### **REMARKS/ARGUMENTS**

Appl. No. 09/845,473  
Amdt. dated September 7, 2004  
Response to Office action of June 15, 2004

Fig. 3

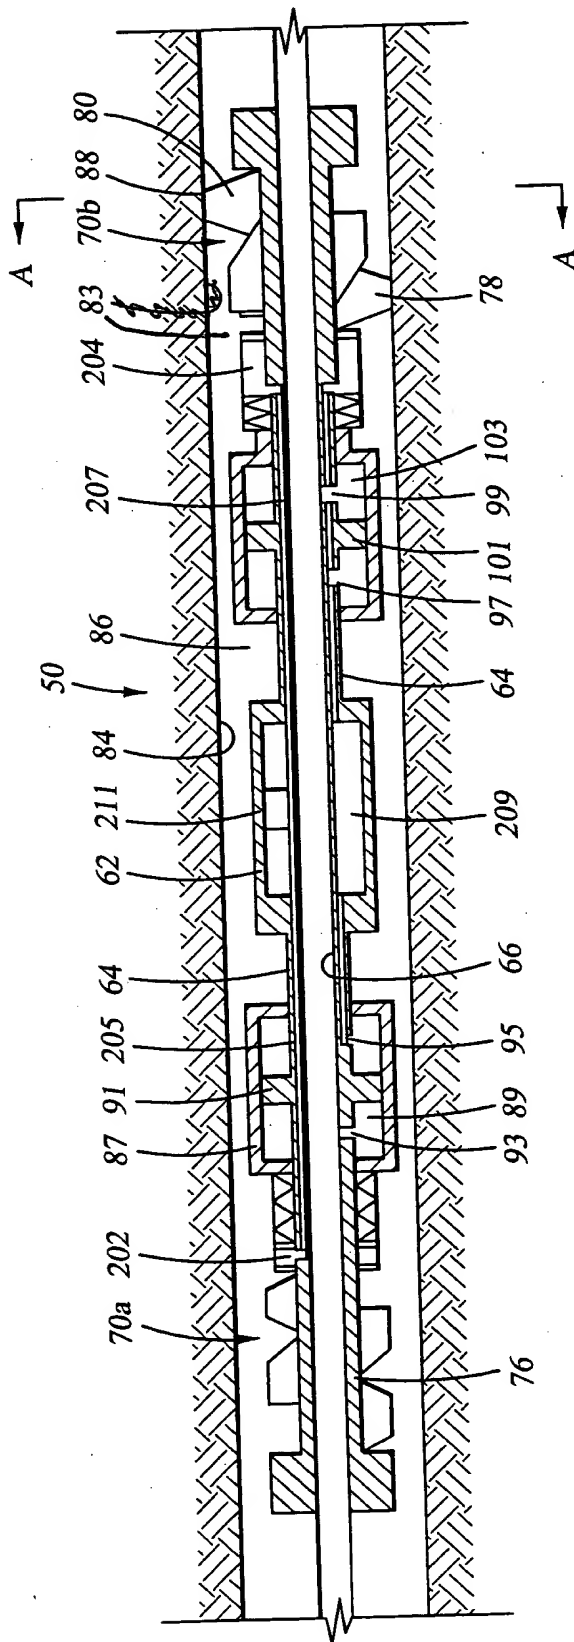
Attached are amended sheets of drawings for Figures 3, 5, 7, 8, 10, and 16-18. The amendments to the Figures are shown in red. In Figure 3, the lead line to the annulus 83 has been corrected. Reference numeral 162 in Figure 5 has been changed to 162a,b. Reference numerals 102a,b have been added to Figure 7 and Reference numerals 122a,b have been added in Figure 8. Likewise reference numerals 168 and 166a have been added to Figure 10. Further reference numerals have been added to Figures 16-18 at the request of the Examiner. Applicant requests that these drawing amendments be approved.

Fig. 5

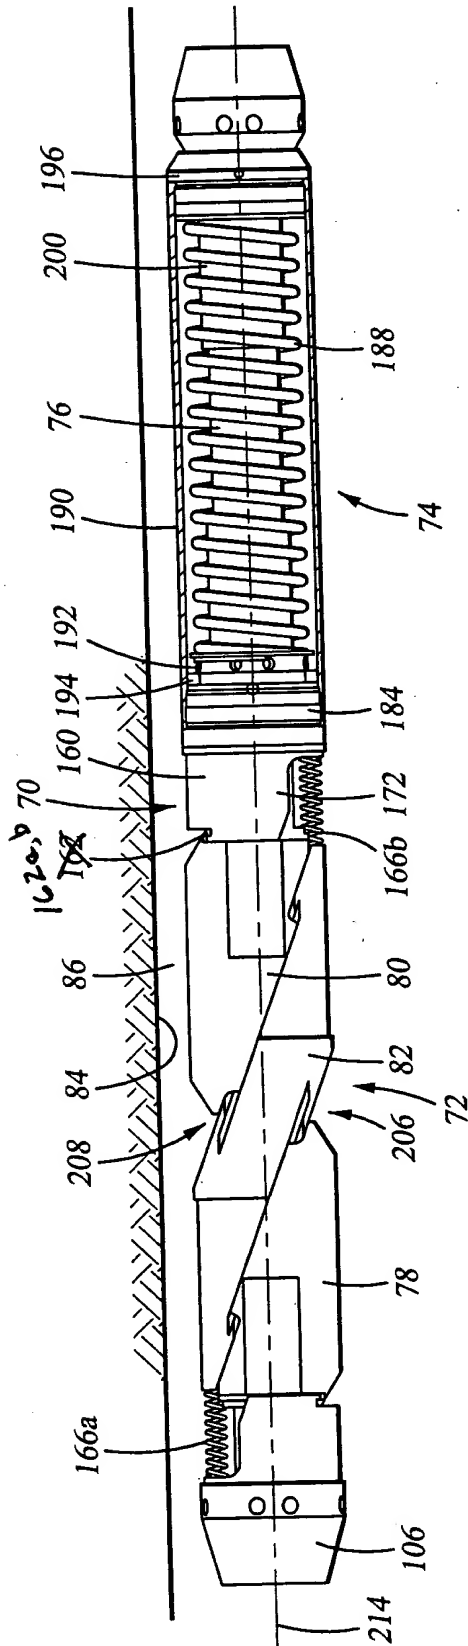
The examiner objected to the drawings as failing to comply with 37 CFR 1.84(p)(5) stating that they do not include the following reference signs mentioned in the description: 102a, 102b, 122a, 122b, 140a, 140b, 142a, 142b, 162a, 162b, 158a, 158b, 166, 124, 118, 158, and 402.

Applicant amends the drawings and the specification as above in accordance with the examiner's objections. Reference numeral 162 in Figure 5 has been changed to 162a,b. Reference

Fig. 7

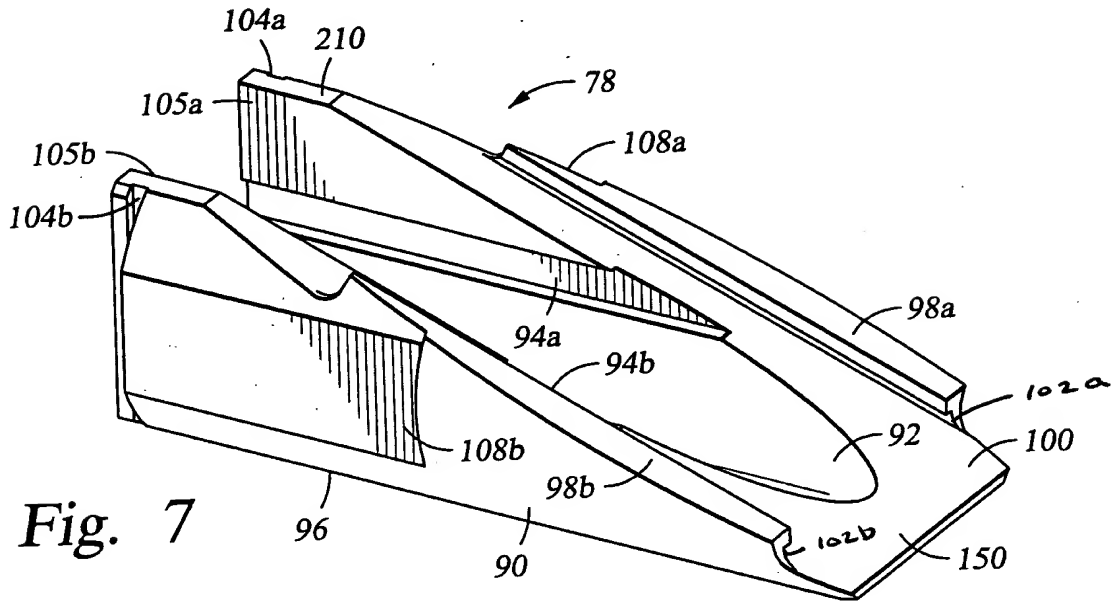
numerals 102a,b have been added to Figure 7 and Reference numerals 122a,b have been added in Figure 8. Likewise reference numerals 168 and 166a have been added to Figure 10. The specification has been amended to refer to reference numeral 140 and 142 instead of 140a,b and 142a,b so that the specification conforms to the drawings. Likewise the specification has been amended to reference numerals 124a,b, 118a,b, 158a,b, and 166a,b. Applicant respectfully submits that the drawings are now in proper form.

Fig. 17

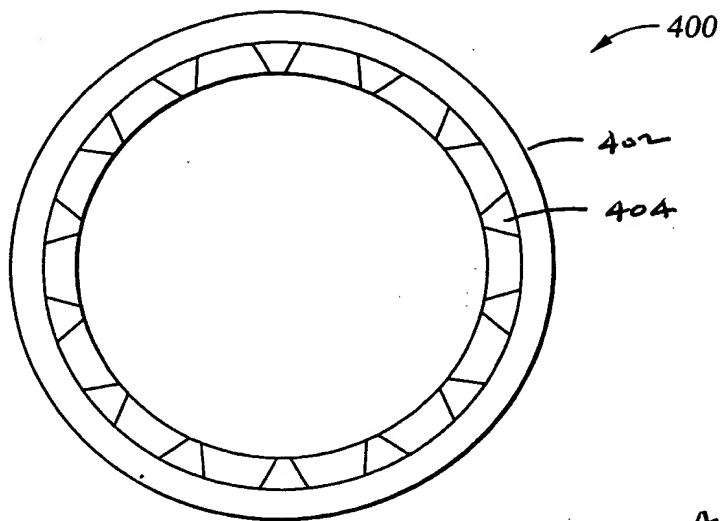
The examiner objected to the drawings stating that Figures 16-18 do not contain any reference numbers that the examiner considers necessary for a complete understanding of the claimed invention. Applicant has added reference numerals 403 and 404 to Figure 16 and has added reference numerals to Figures 17 and 18 based on the disclosure from pages 11-16 of U.S. Provisional application No. 60/201,193, filed May 2, 2000 and entitled Traction Module incorporated by reference in paragraph [057] in the present application. New paragraphs [057.1]-[057.10] from pages 11-16 of U.S. Provisional application No. 60/201,193, filed May 2, 2000 and entitled Traction Module incorporated by reference in paragraph [057] in the present application have also been added for the description of the newly added reference numerals. No new matter has been added. In view of these amendments, Applicant respectfully submits that Figures 16-18 are now in proper form.
